RIGHT OF WAY PLAN OF THE
BENSON - MAMMOTH
STATE HIGHWAY
PROJECT NO. S-358-706
PIMA
COUNTY

BENSON-MAMMOTH HIGHWAY
REDINGTON BRIDGE-PINAL COUNTY LINE SEC.
PIMA COUNTY

PROJECT NO.	S-358-706
DRAWING NO.	D-10-T-321
SHEET NO.	2 of 17
DRAWN BY	J.G.
DATE COMP.	8-4-70
SCALE	
CONSULTANT	ENG. CORP OF AMERICA

PROJECT NO.	5-358-706
DRAWING NO.	D-10T-321
SHEET NO.	7 of 17
DRAWN BY	P.U.H.
DATE COMP.	8-4-70
SCALE	1"=100'
CONSULTANT	ENG. CORP. OF AMERICA

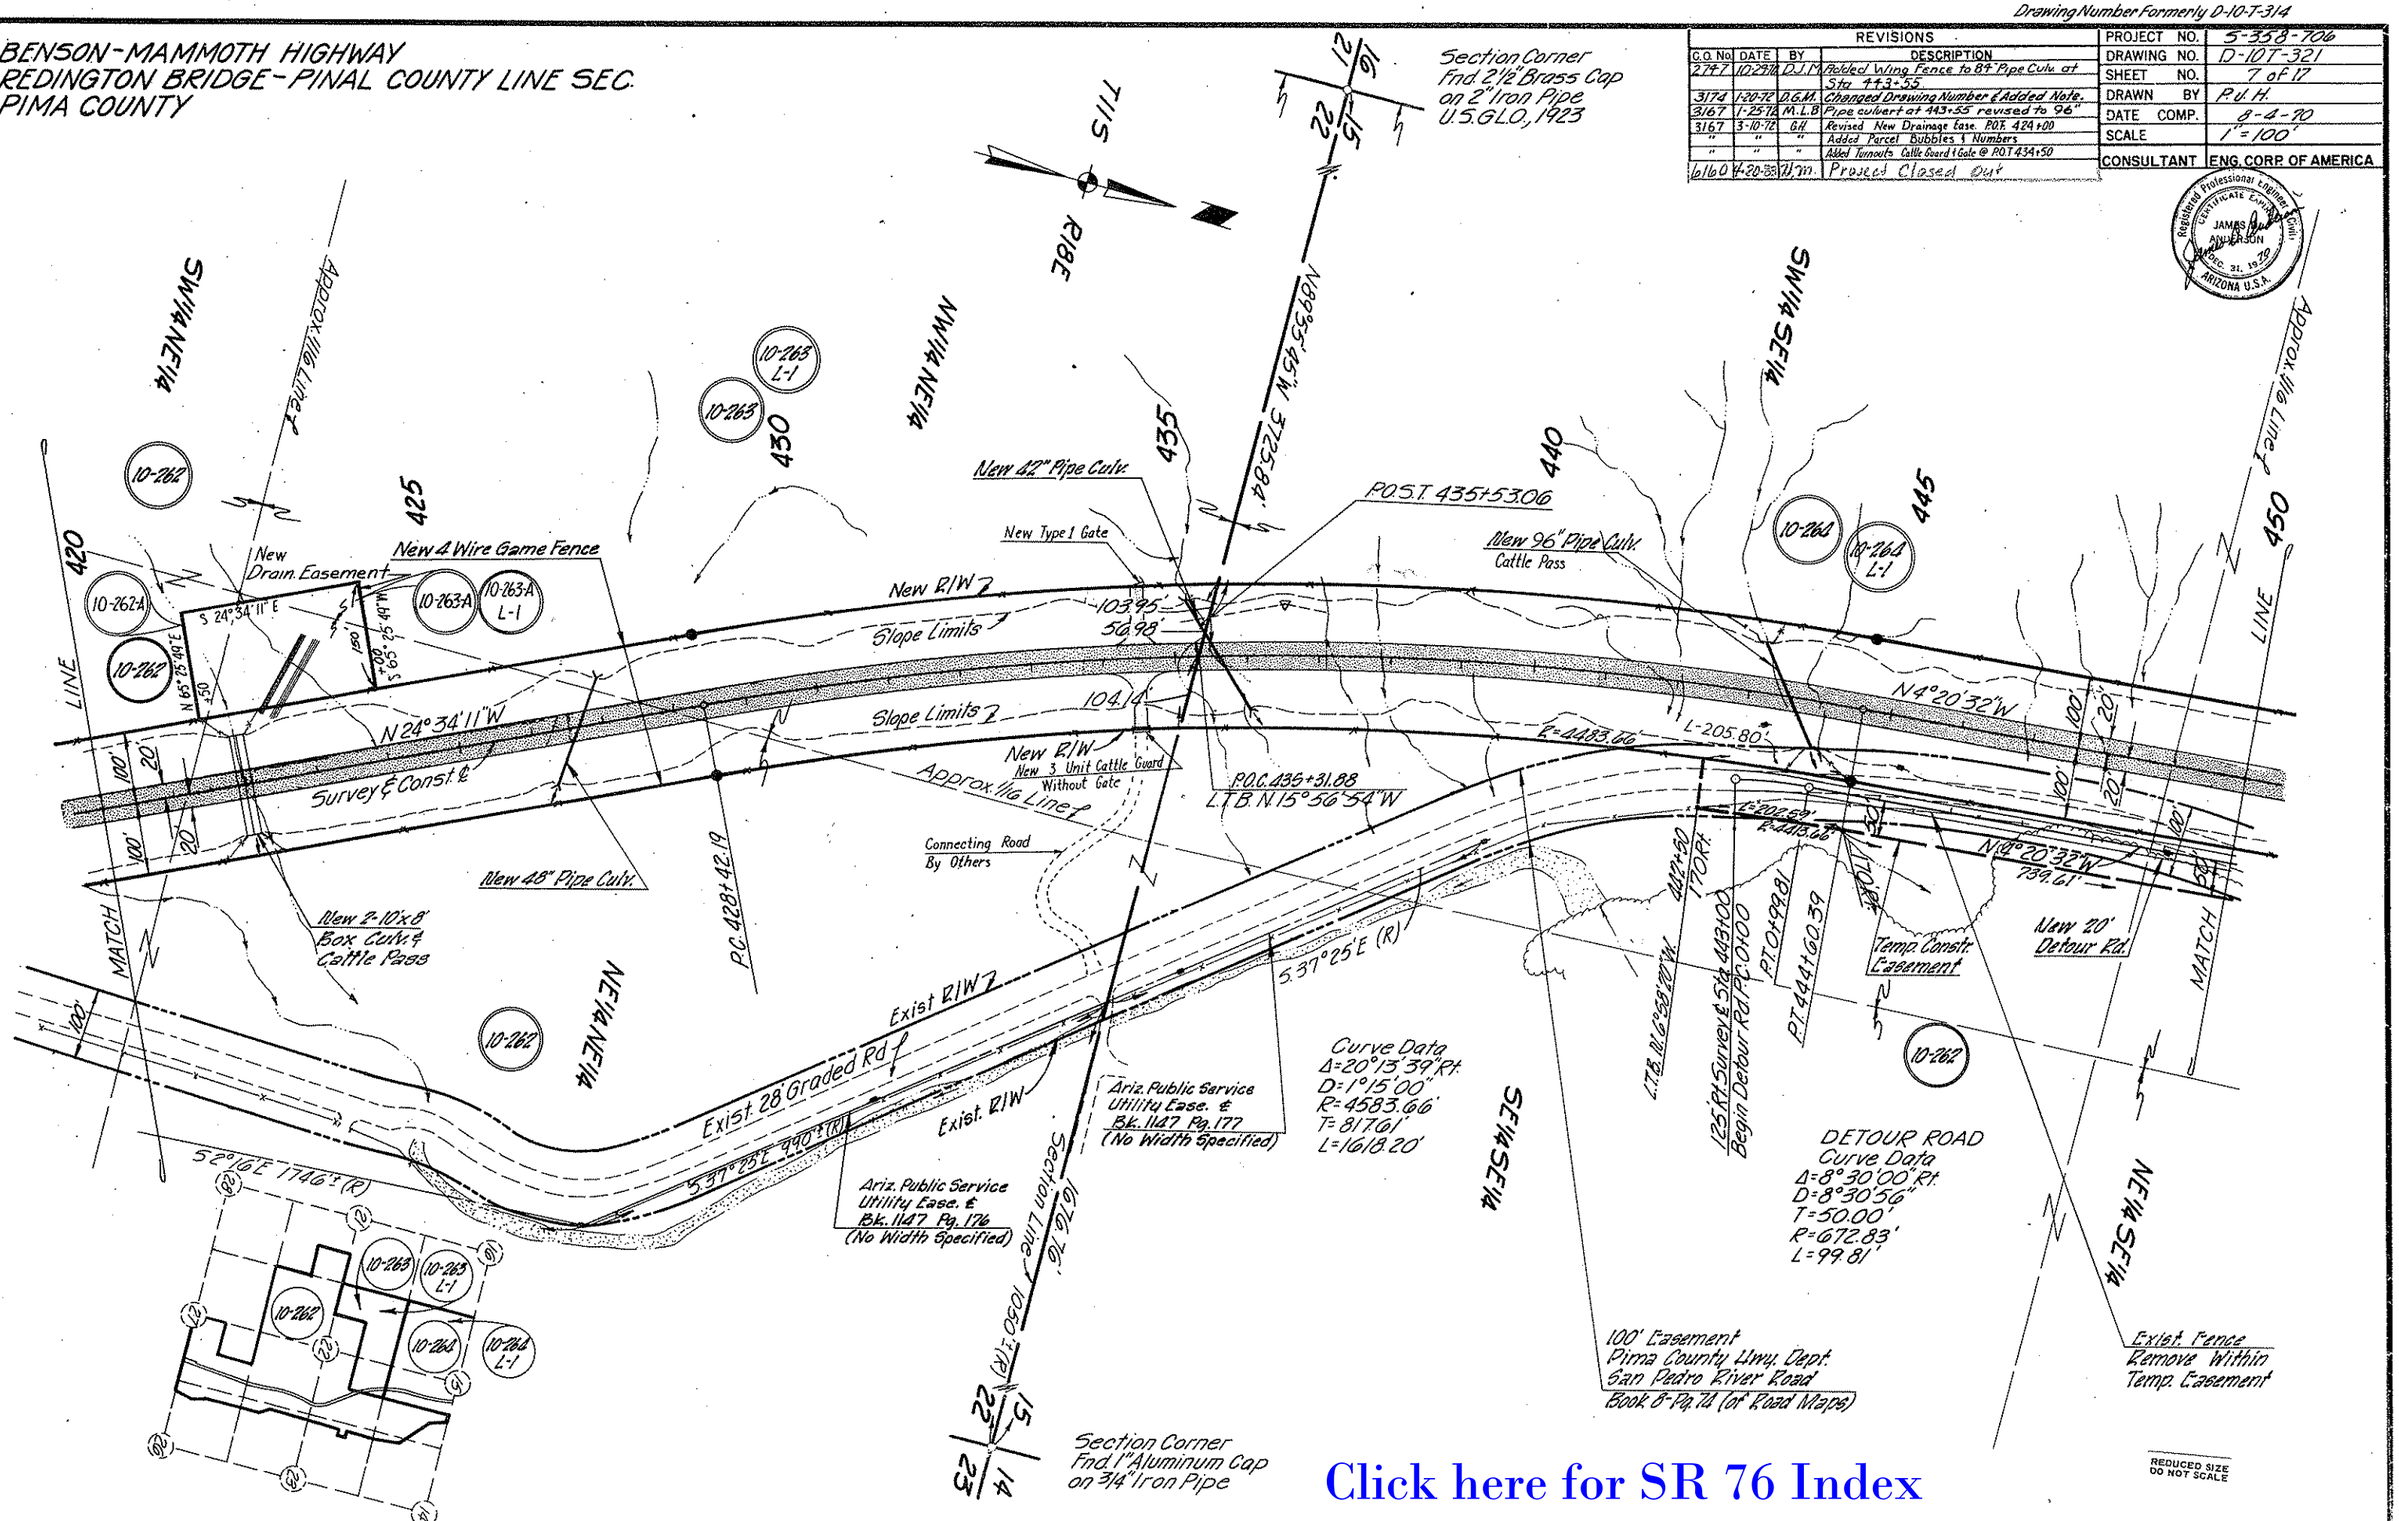
REVISIONS			
C.O. No.	DATE	BY	DESCRIPTION
2747	10-29-70	D.J.M.	Added Wing Fence to 84" Pipe Culv. at Sta. 443+55
3174	1-20-72	D.G.M.	Changed Drawing Number & Added Note.
3167	1-25-72	M.L.B.	Pipe culvert at 443+55 revised to 96"
3167	3-10-72	G.H.	Revised New Drainage Ease. P.O.T. 424+00
"	"	"	Added Parcel Bubbles & Numbers
"	"	"	Added Turnouts Cattle Guard & Gate @ P.O.T. 434+50
6160	4-20-83	W.M.	Project Closed Out

PROJECT NO.	5-358-706
DRAWING NO.	D-10-T-321
SHEET NO.	8 of 17
DRAWN BY	P.J.H.
DATE COMP.	8-4-70
SCALE	1" = 100'
CONSULTANT	ENG. CORP. OF AMERICA

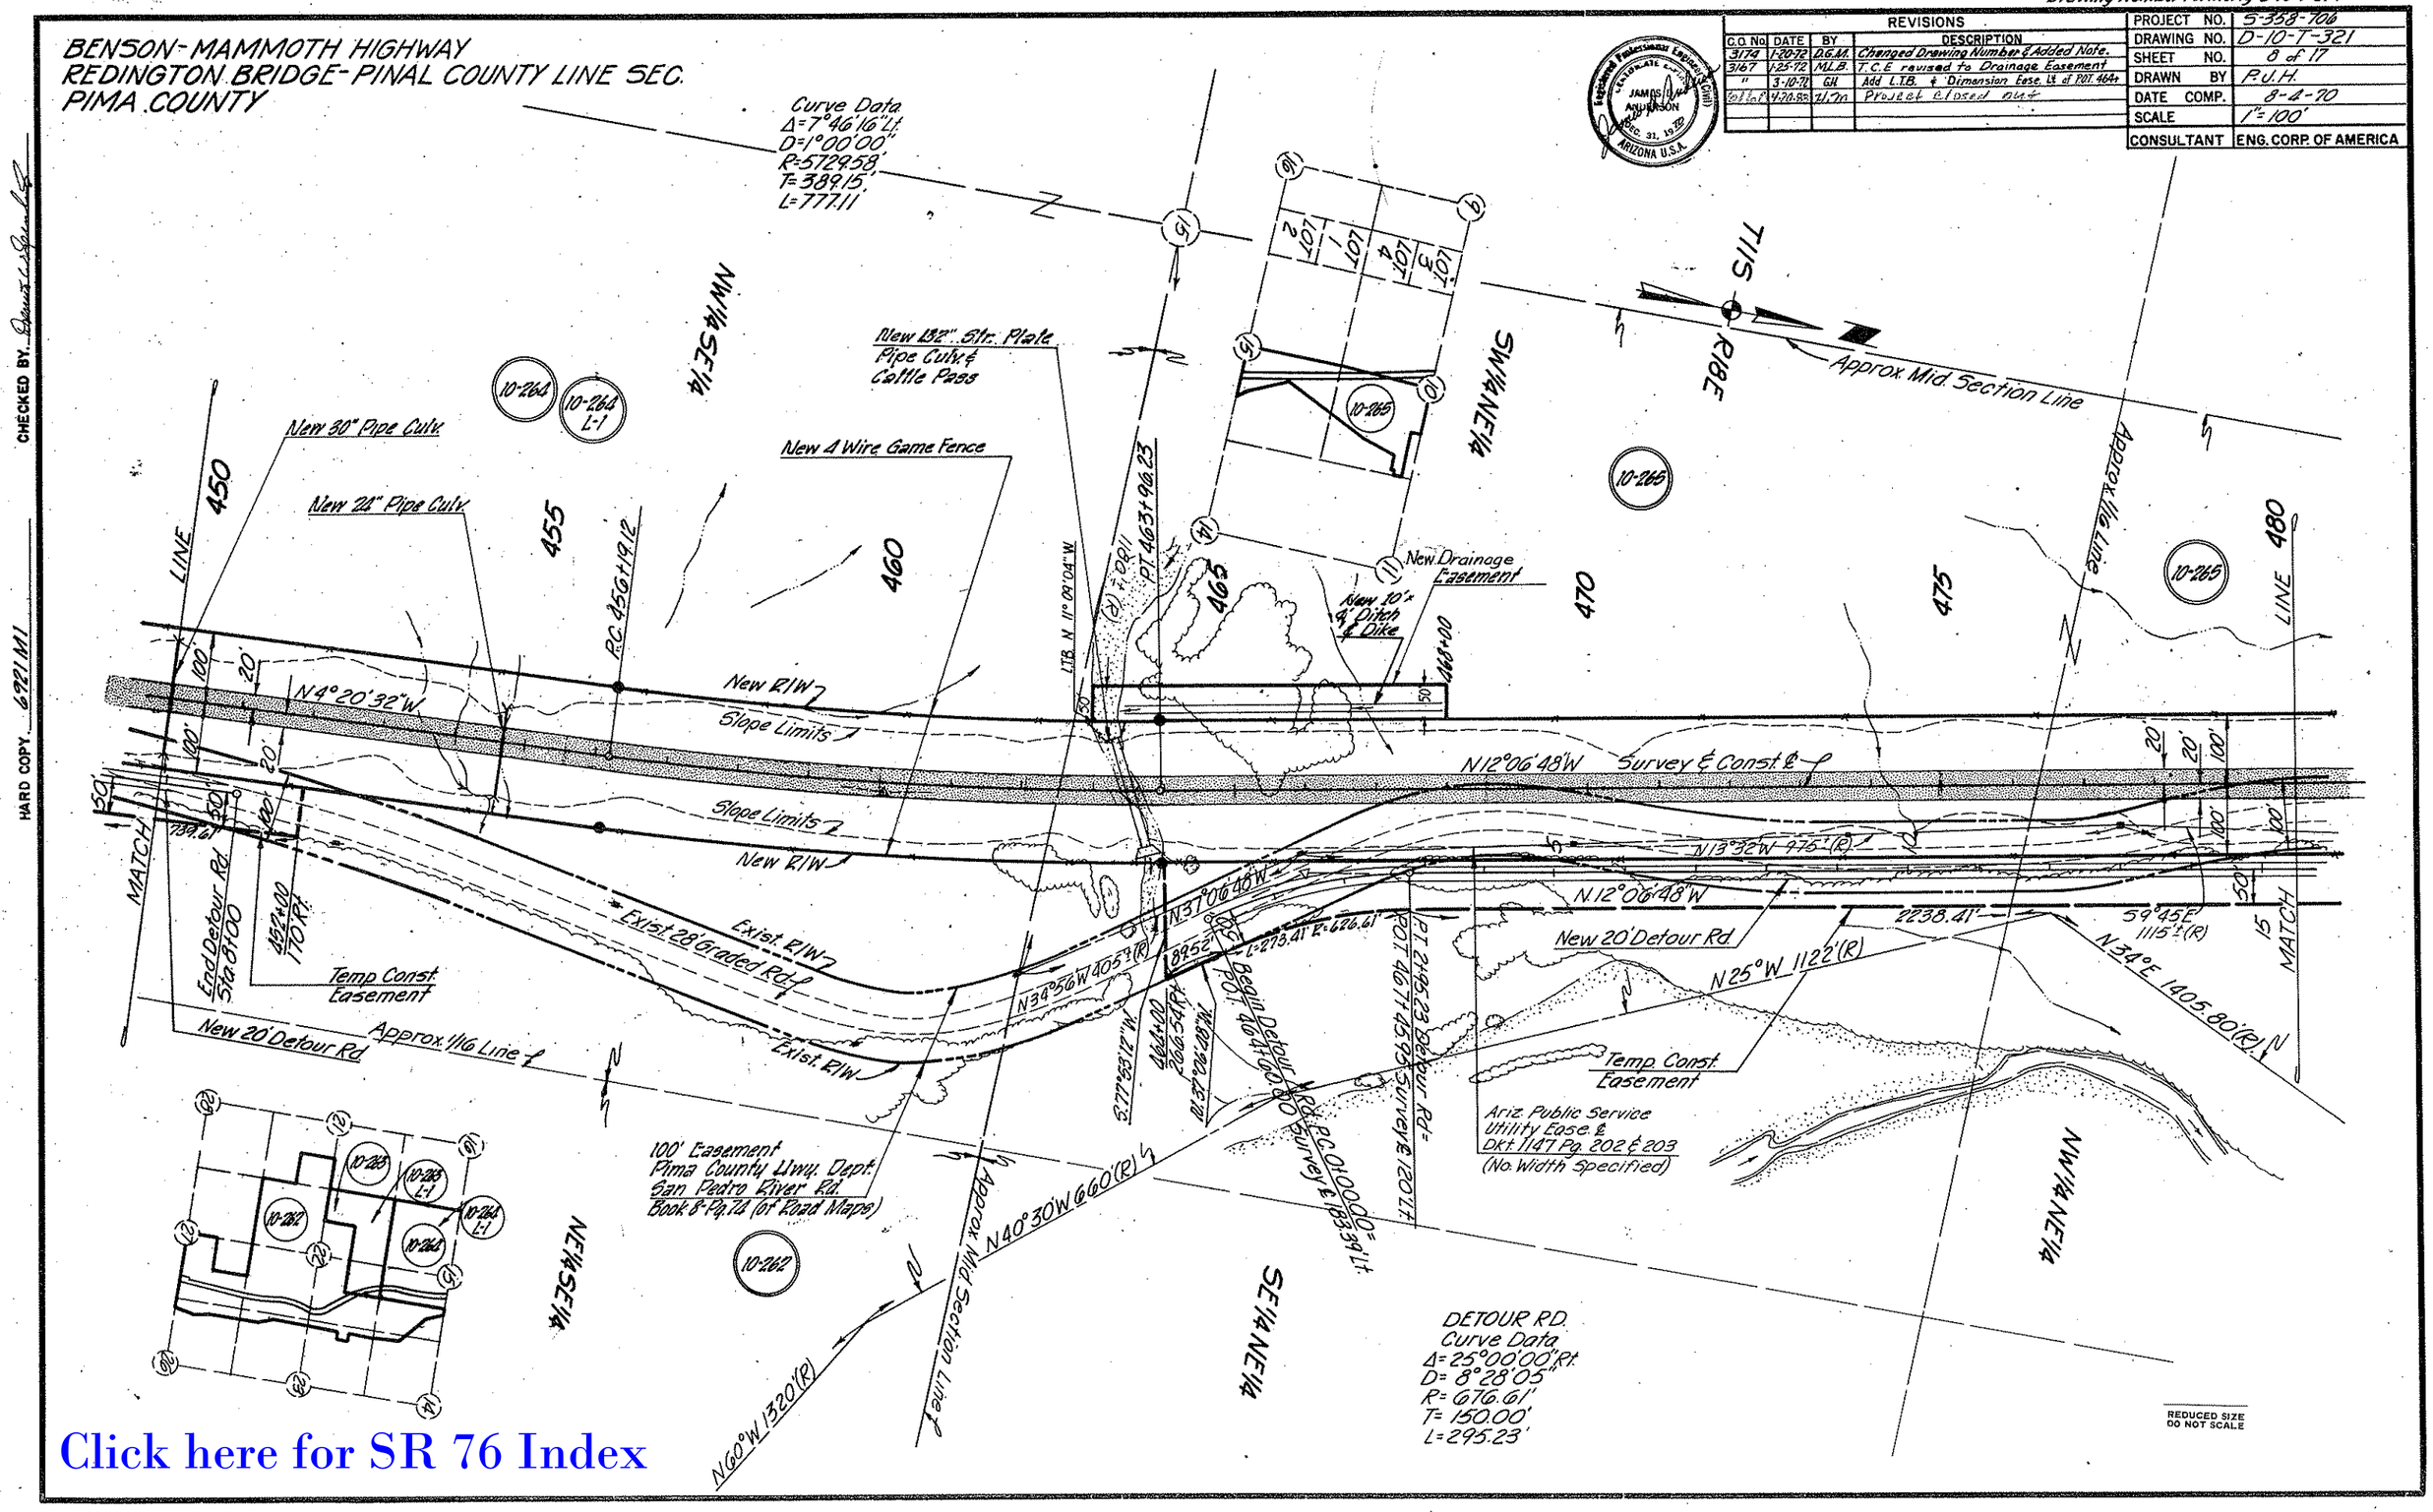
REVISIONS			
C.O. No.	DATE	BY	DESCRIPTION
3174	1-20-72	D.G.M.	Changed Drawing Number & Added Note.
3167	1-25-72	M.L.B.	T.C.E revised to Drainage Easement
"	3-10-72	GH	Add L.T.B. & Dimension Ease. Lt of P.O.T. 464+
Collar	4-20-83	J.L.M.	Project closed out

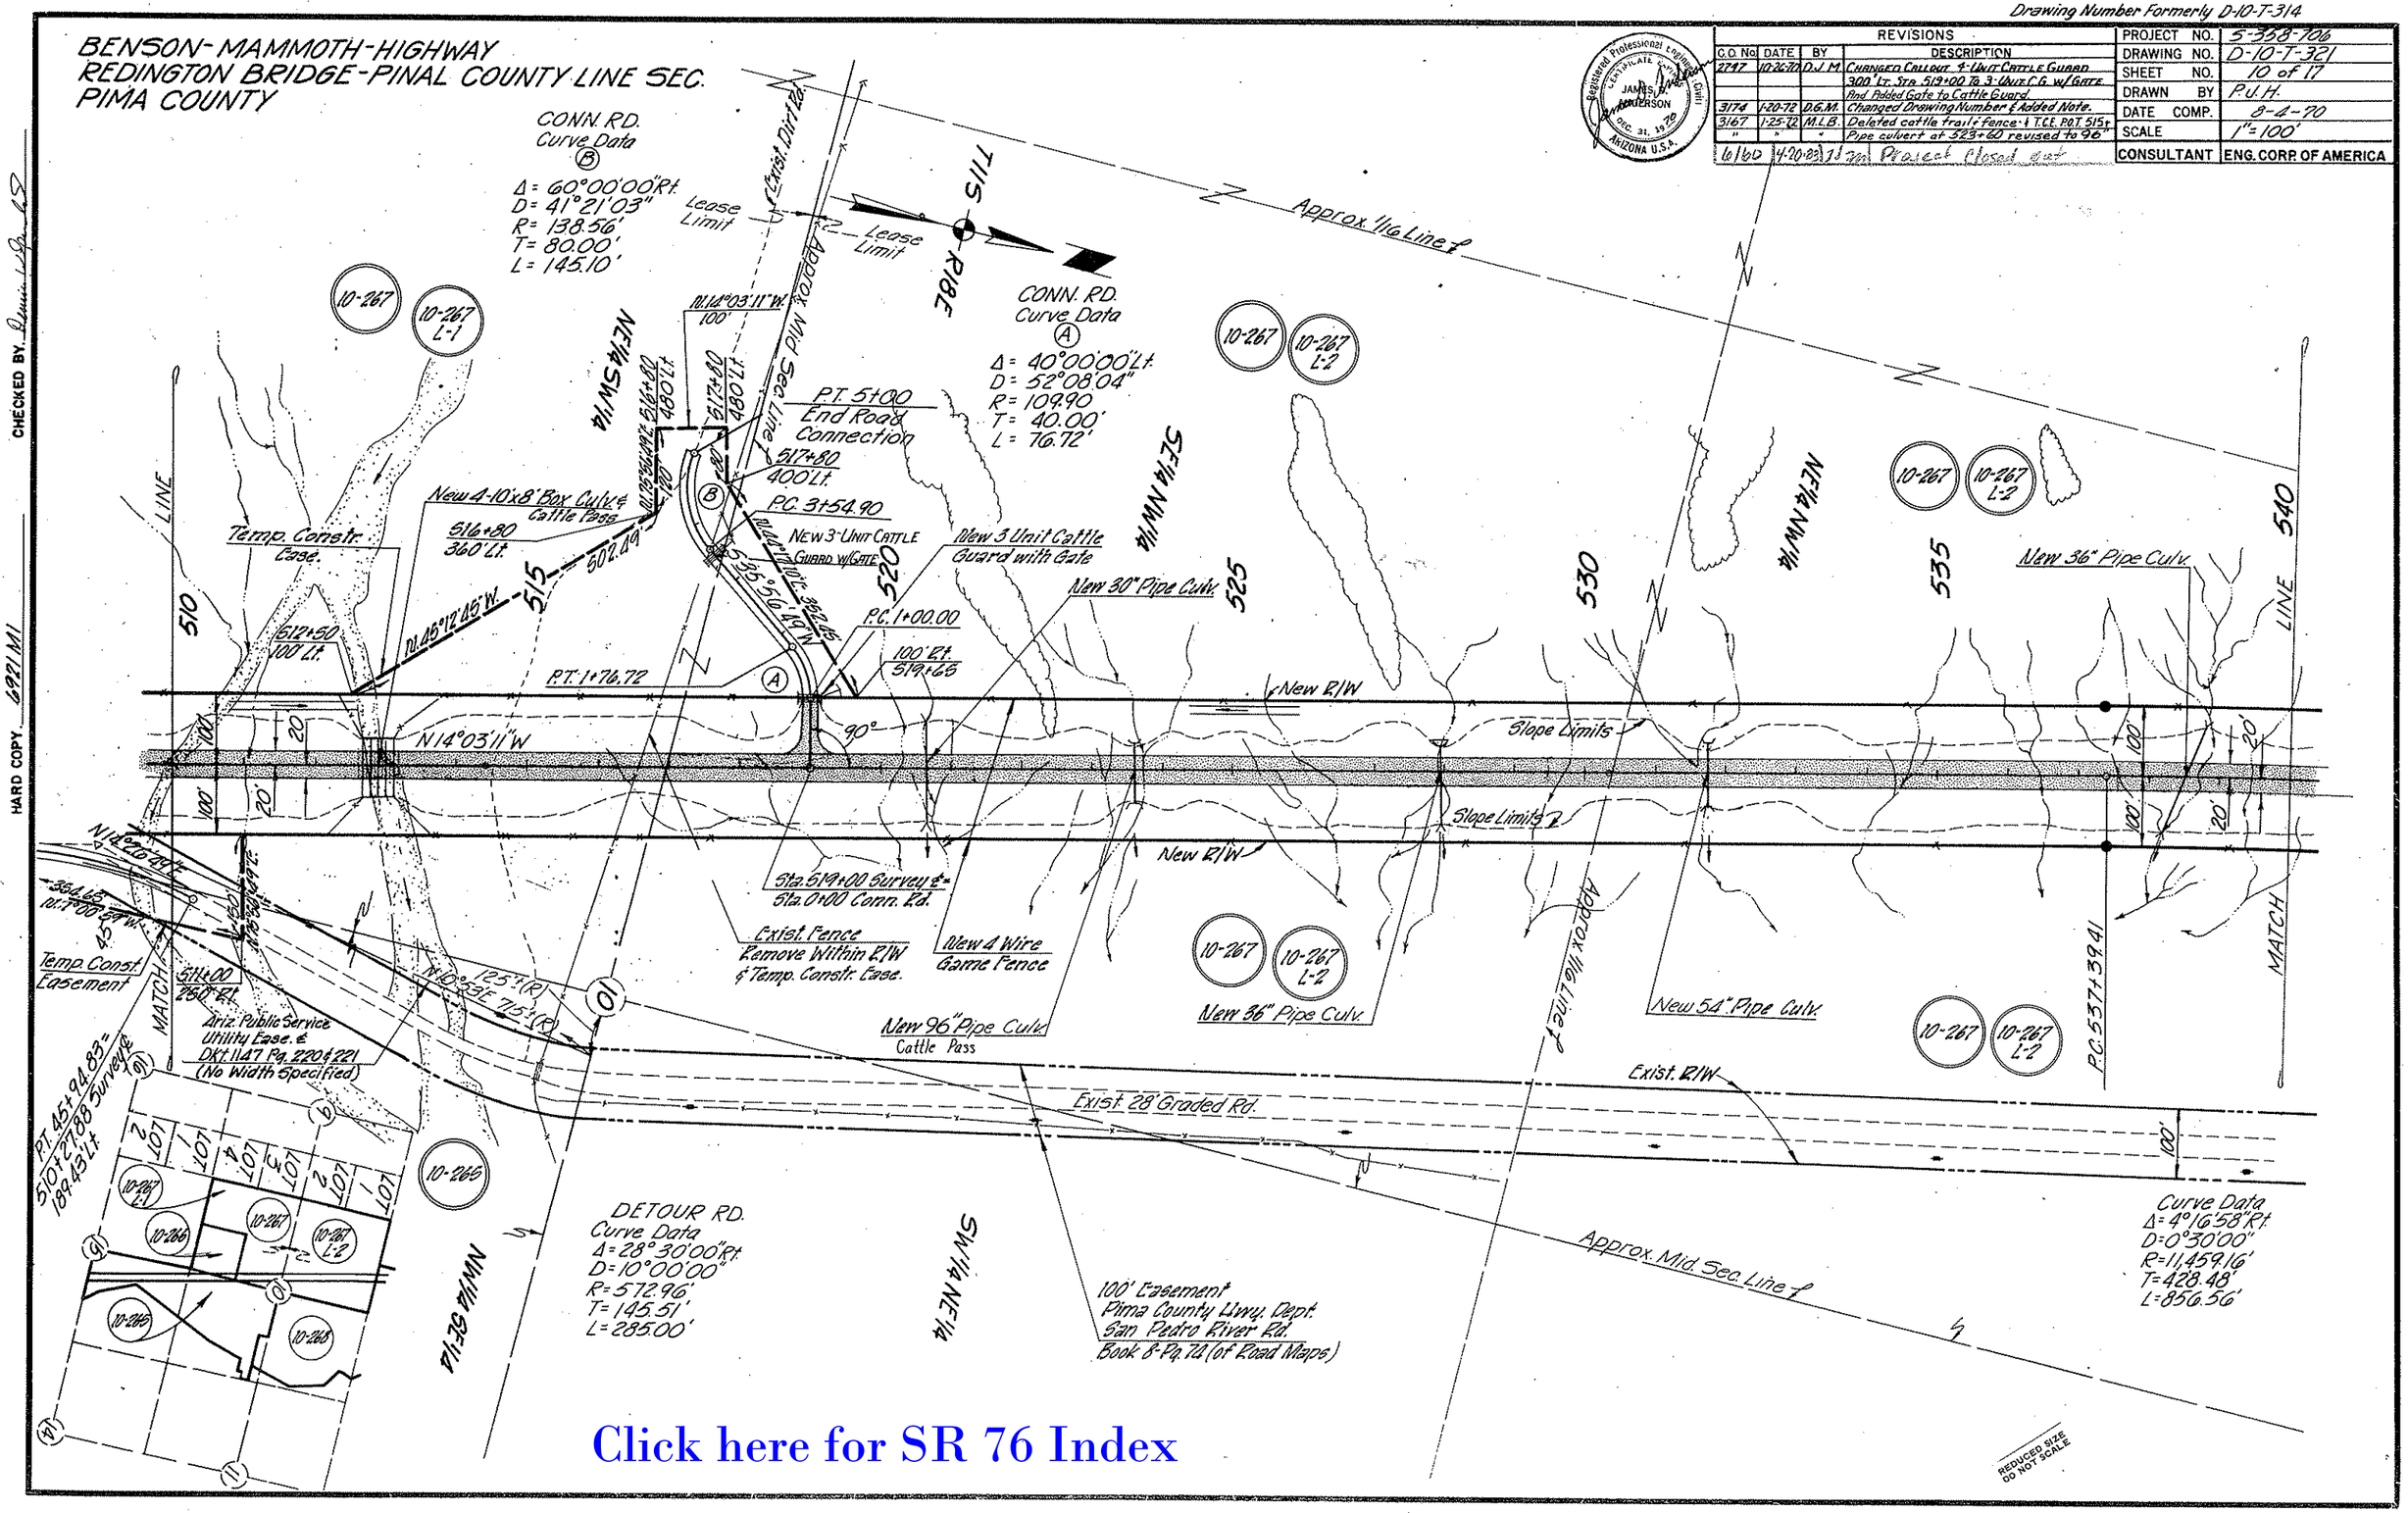
REVISIONS					
C.O. No.	DATE	BY	DESCRIPTION	PROJECT NO.	5-358-706
2747	10-26-70	D.J.M.	Changed Callout 4-Unit Cattle Guard 300' Lt. Sta. 519+00 To 3-Unit C.G. w/Gate And Added Gate to Cattle Guard.	DRAWING NO.	D-10-T-321
3174	1-20-72	D.G.M.	Changed Drawing Number & Added Note.	SHEET NO.	10 of 17
3167	1-25-72	M.L.B.	Deleted cattle trail & fence & T.C.E. P.O.T. 515+	DRAWN BY	P.J.H.
"	"	"	Pipe culvert at 523+60 revised to 96"	DATE COMP.	8-4-70
6160	4-20-83	JJM	Project Closed out	SCALE	1"=100'
				CONSULTANT	ENG. CORP. OF AMERICA
